HOPE CREEK GENERATING STATION
DOCKET NO. 50-354
DRAFT SAFETY EVALUATION REPORT
OPEN ITEM STATUS

Attachment 1 is a current list which provides a status of the open items identified in Section 1.7 of the Draft Safety Evaluation Report (SER). Items identified as "complete" are those for which PSE&G has provided responses and no confirmation of status has been received from the staff. We will consider these items closed unless notified otherwise. In order to permit timely resolution of items identified as "complete" which may not be resolved to the staff's satisfaction, please provide a specific description of the issue which remains to be resolved.

In addition, enclosed for your review and approval (see Attachment 4) are the resolutions to the Draft SER open items and the resolution of comments received during the April 17 and 18, 1984, Power Systems Branch (Mechanical) meeting on the 430 questions series, listed in Attachment 3. A signed original of the required affidavit is provided to document the submittal of these DSER open item and FSAR question responses.

FIGURE 421.23-1 AMENDMENT 7, 08/84

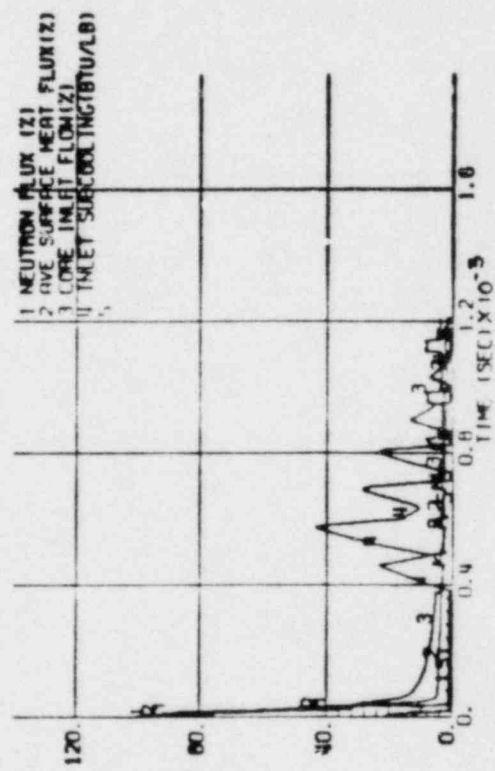
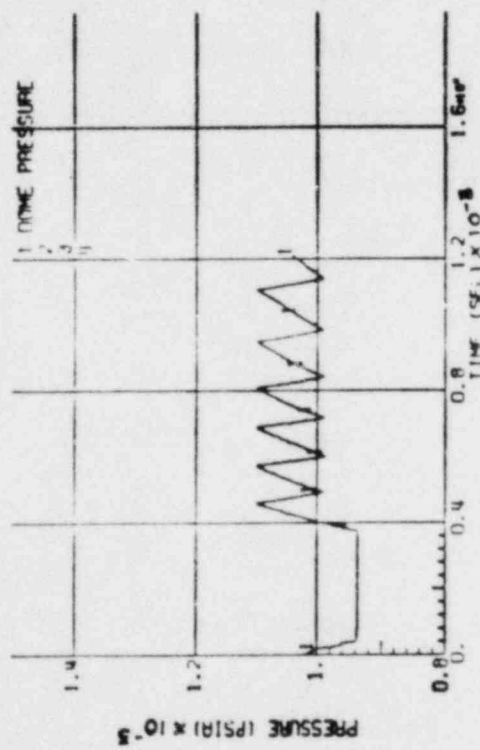
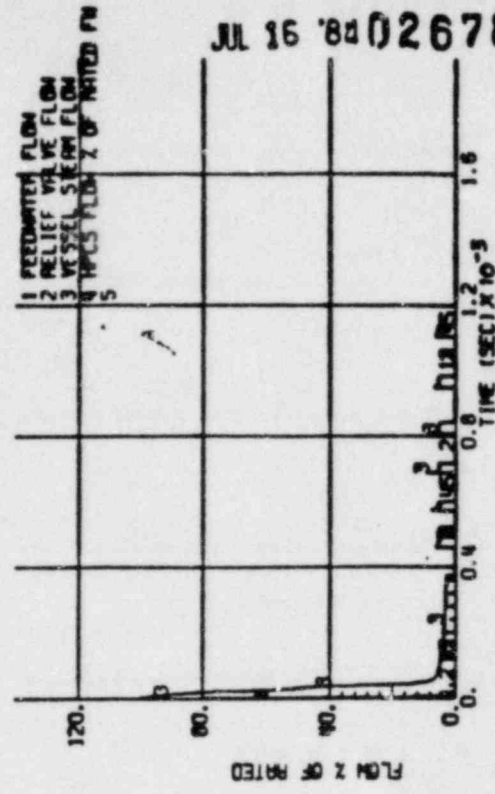
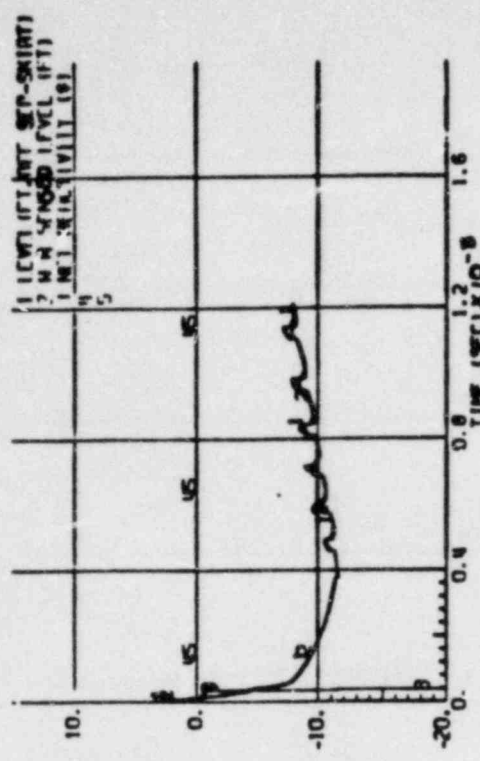
The case with the EOC void-reactivity coefficient showed that the minimum water level would be between level 1 and level 2. Figures 421.23-1 and 421.23-2 show the REDY plots for the cases with the BOC void-reactivity coefficient and the EOC void-reactivity coefficient, respectively. The case with the BOC void-reactivity coefficient showed that the minimum water level would be below level 1 outside the shroud and would trigger the closure of the MSIVs.

FIGURE 421.23-3 AMENDMENT 7, 08/84

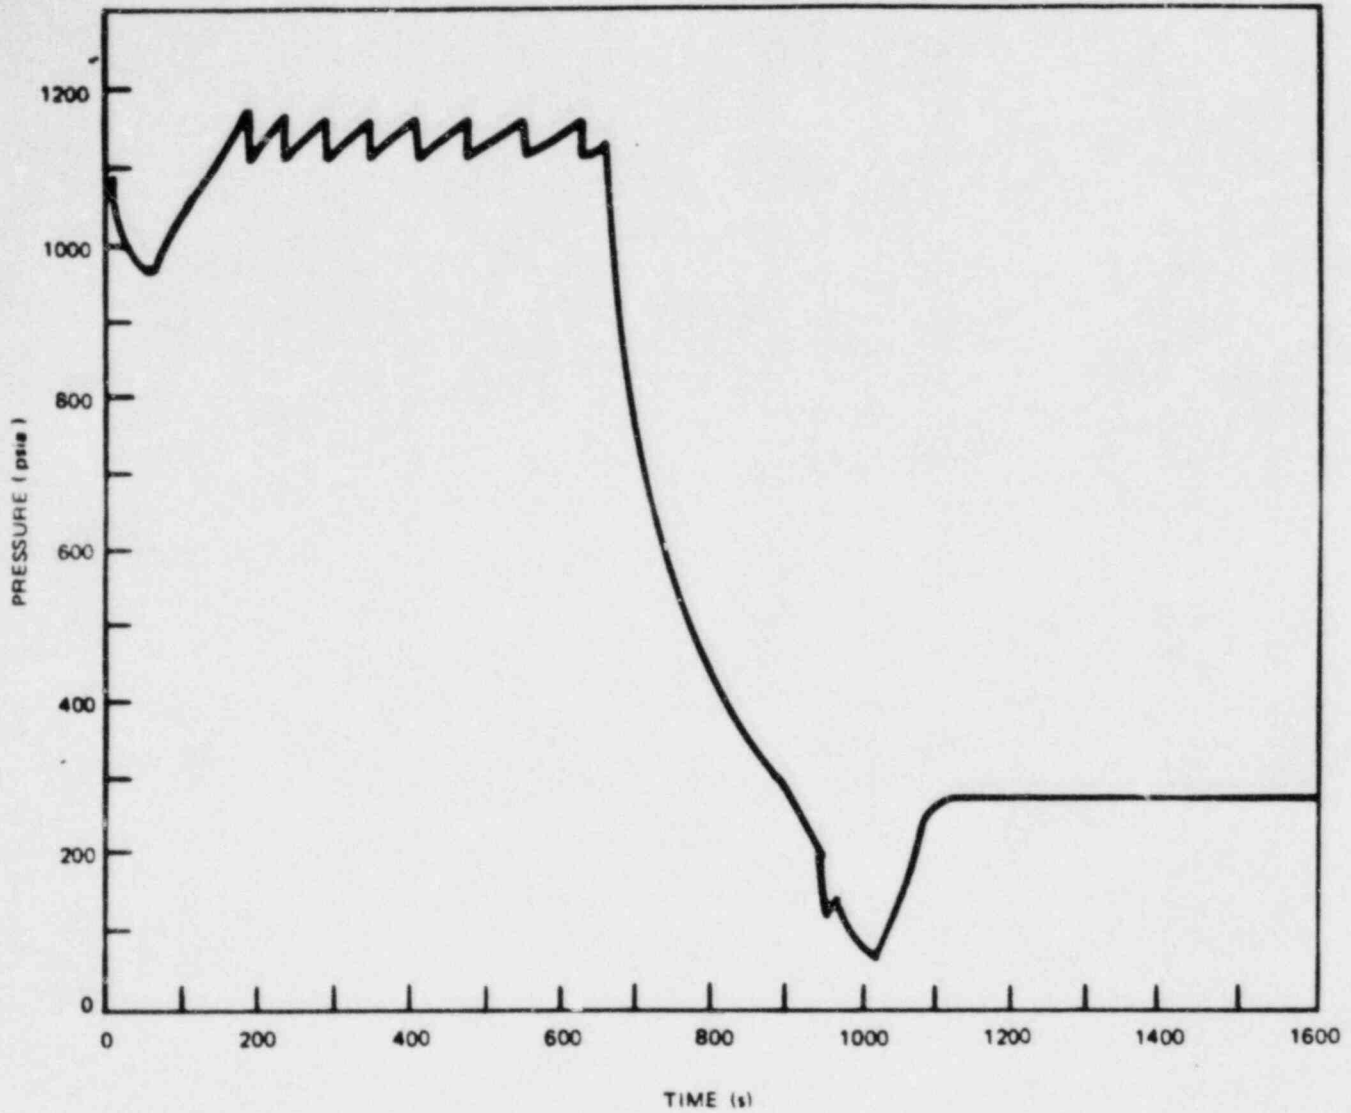
Figures 421.23-3 through 421.23-5 show the system pressure, water level inside the shroud, and peak cladding temperature (PCT), respectively, calculated from the core-heatup analysis. The minimum water level in the core would be 2.5 feet below the top of the active fuel (inside the shroud). This uncover level would result in a PCT of 450°F. Since this PCT is less than the initial cladding temperature of 644°F and well below the 2200°F limit, these results are acceptable from an ECCS viewpoint.

FIGURE 8.2.2

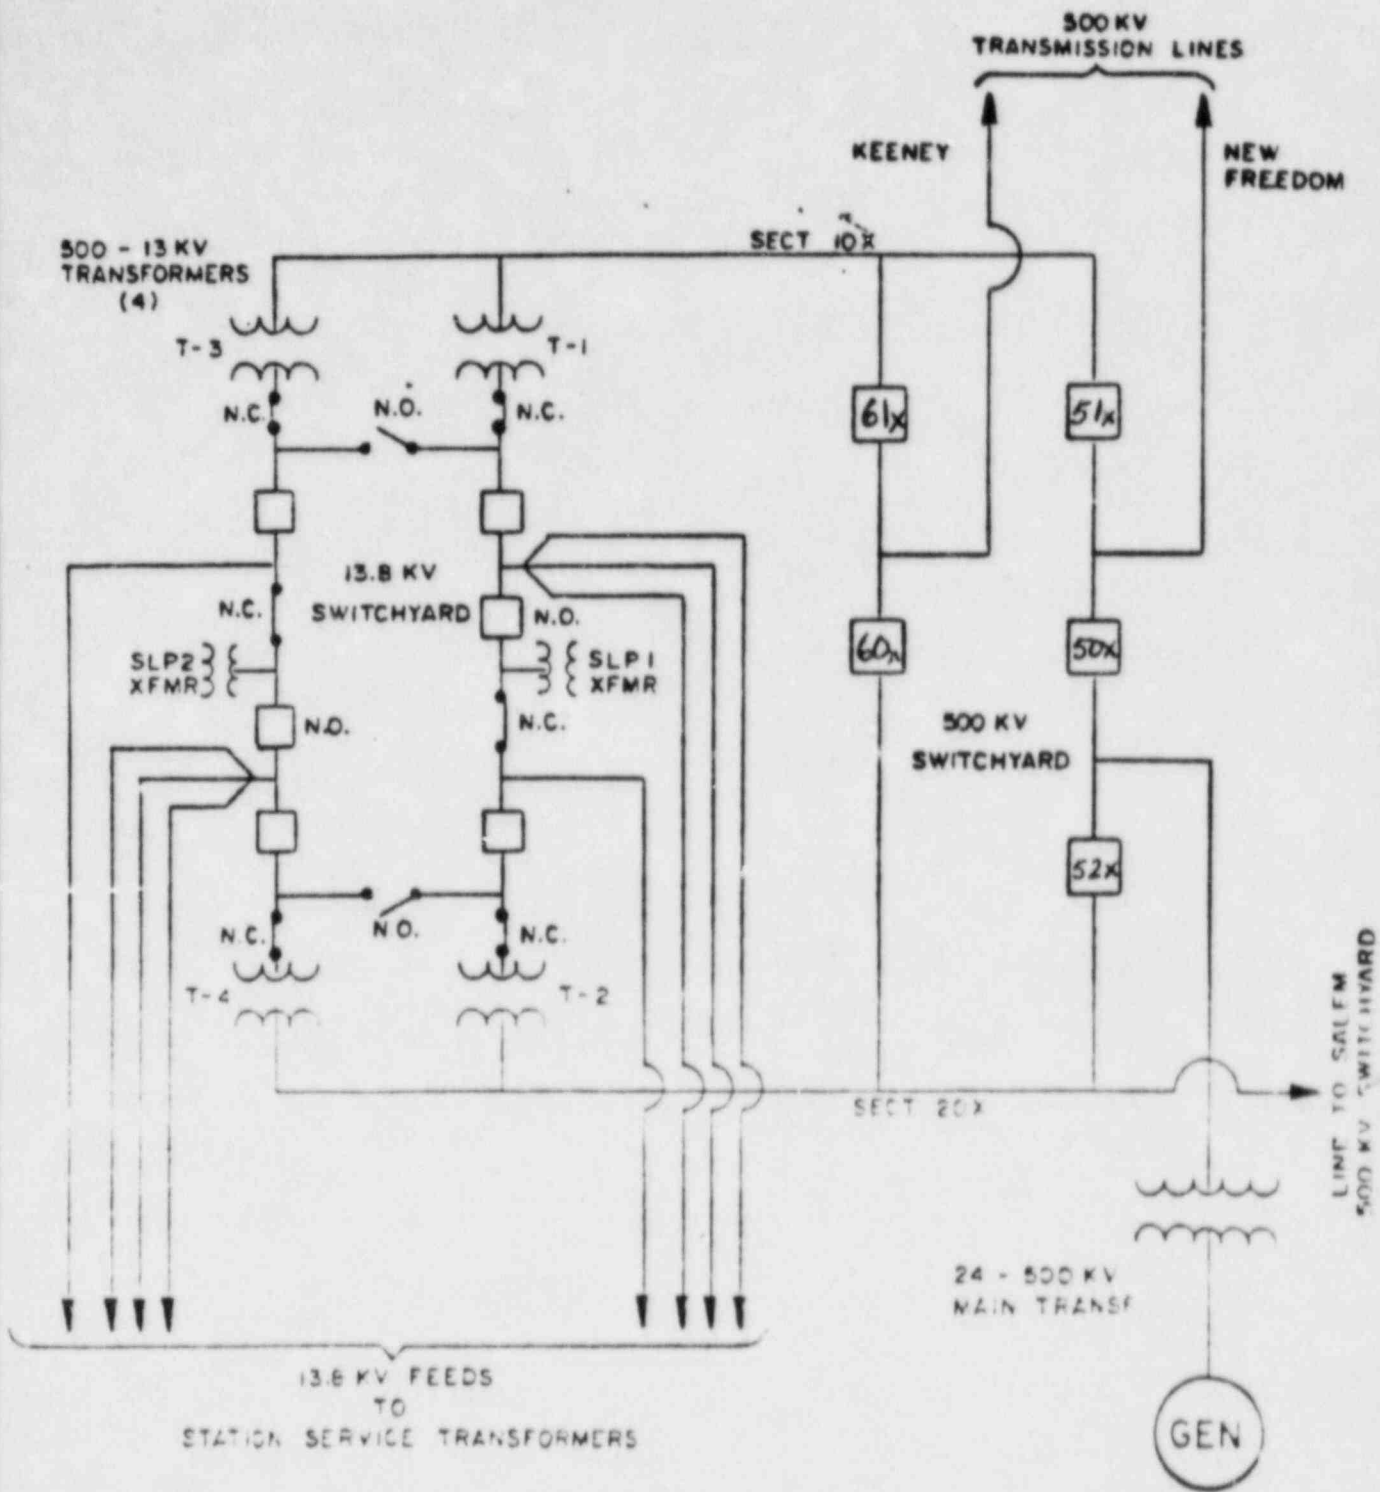
FSAR section 8.2.1.4 and Figure 8.2-2 have been revised to provide the requested information.

As shown on Figure 8.2-2, there are six 13.8-kV, 1500-MVA oil circuit breakers. Breaker failure protection detects the failure to trip or failure to interrupt conditions at the line terminals and electrically isolates faulty equipment. Primary and backup relay protection on the 500/14.4-kV station power transformers is provided by the use of harmonic restraint differential relays.

THE 500 KV CIRCUIT BREAKERS ARE PNEUMATICALLY OPERATED AND EACH BREAKER HAS SUFFICIENT STORED AIR FOR A MINIMUM OF THREE OPERATIONS WITHOUT COMPRESSOR ACTUATION. THE COMPRESSOR MOTOR IS FED FROM THE BREAKER A.C. DISTRIBUTION PANEL, WHICH IS PROVIDED WITH TWO INDEPENDENT A.C. CIRCUITS FROM THE SWITCHYARD CONTROL HEAVIS (THE CONTROL HEAVIS ARE THE SWITCHYARD CONTROL HEAVIS). THESE HEAVIS HAVE INDEPENDENT AND SIMULTANEOUS CONTROL OF THE 500 KV CIRCUIT BREAKERS. THE ELECTRIC SYSTEM CREATION CENTER, LOCATED IN NEWARK, N.J., HAS LIMITED CONTROL OF THE LINE BREAKERS^{51X, 60X, AND 61X} AND THE TIE BREAKER^{50X}, AND NO CONTROL OF THE GENERATOR BREAKER^{52X}.

NEW SHEET 21.

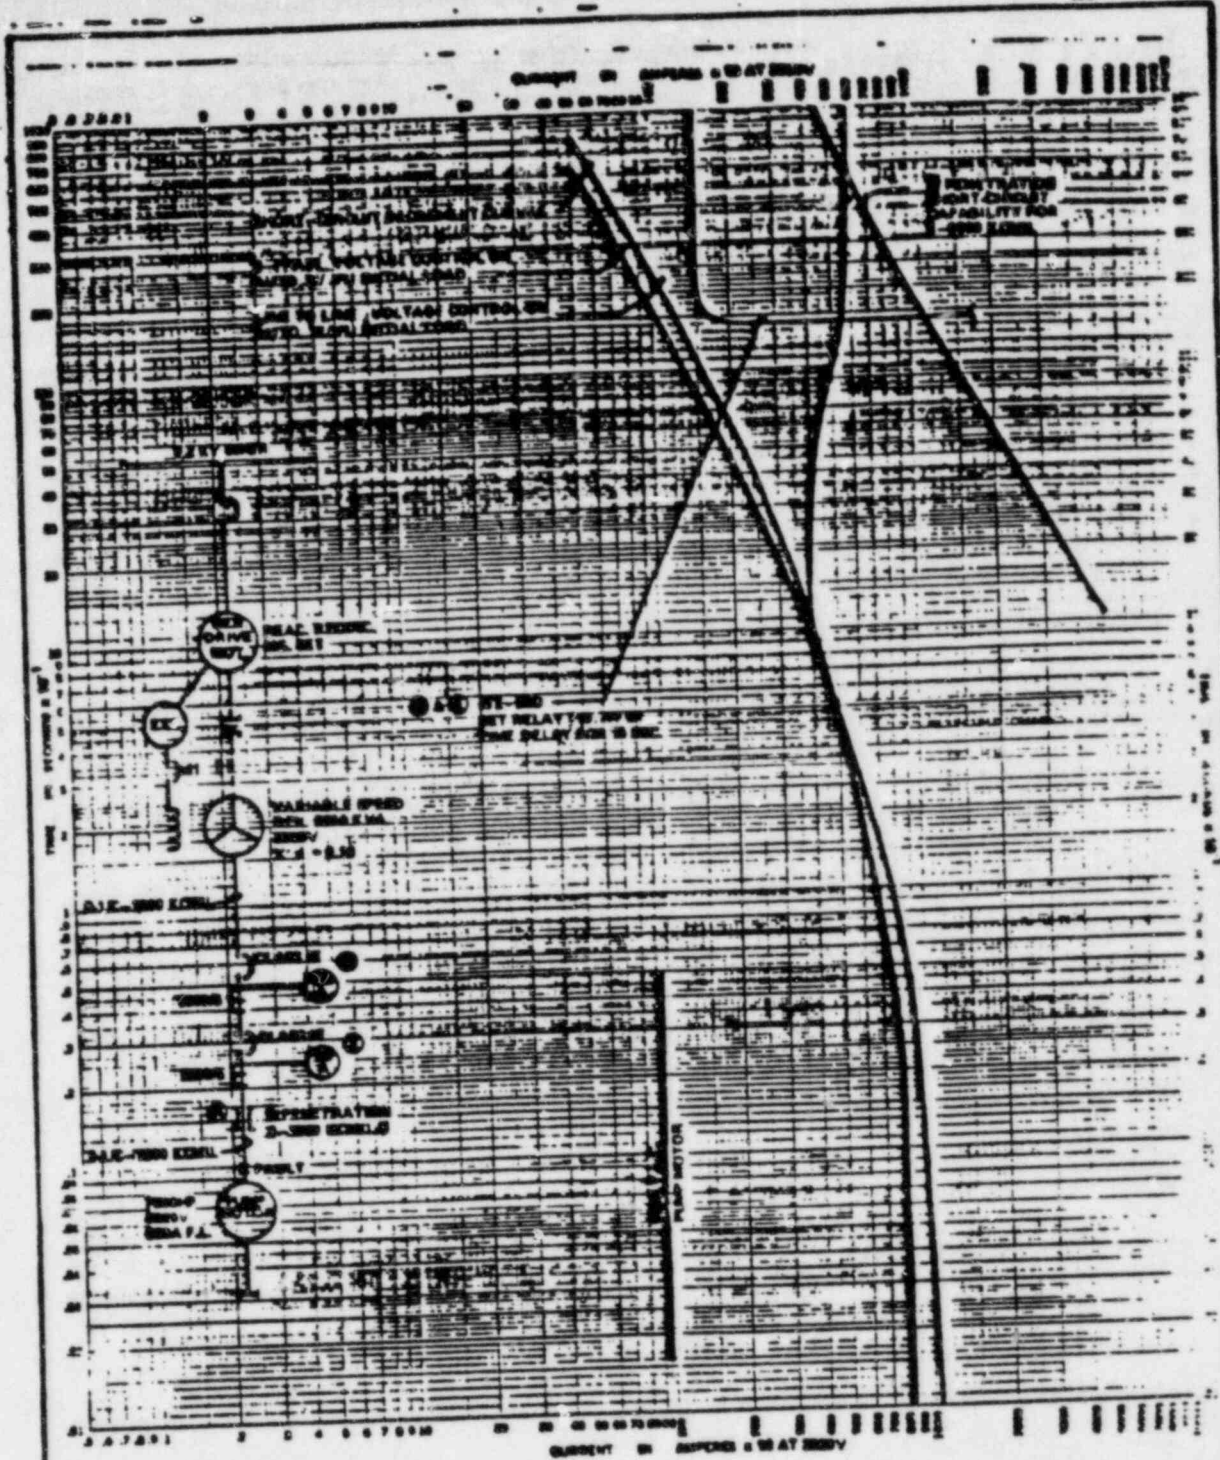
DELETE THOSE TWO CURVES. THE NEW SHEET 22 INCORPORATES THE TIME-CURRENT CHARACTERISTICS OF THE CLASS 16 PROTECTIVE RELAYS ADDED TO THE RPT CIRCUIT BREAKERS.
 REPLACED BY NEW SHEET 22 (ATTACHED)

FIGURE 430.46-1 SHEET 21 IS A TYPICAL COORDINATION CURVE FOR A #16 AWG PENETRATION FOR RTD AND THERMOCOUPLE CIRCUITS. THE CURVES SHOW THAT THE PENETRATION IS PROTECTED FOR THE MAXIMUM SHORT-CIRCUIT CURRENT.
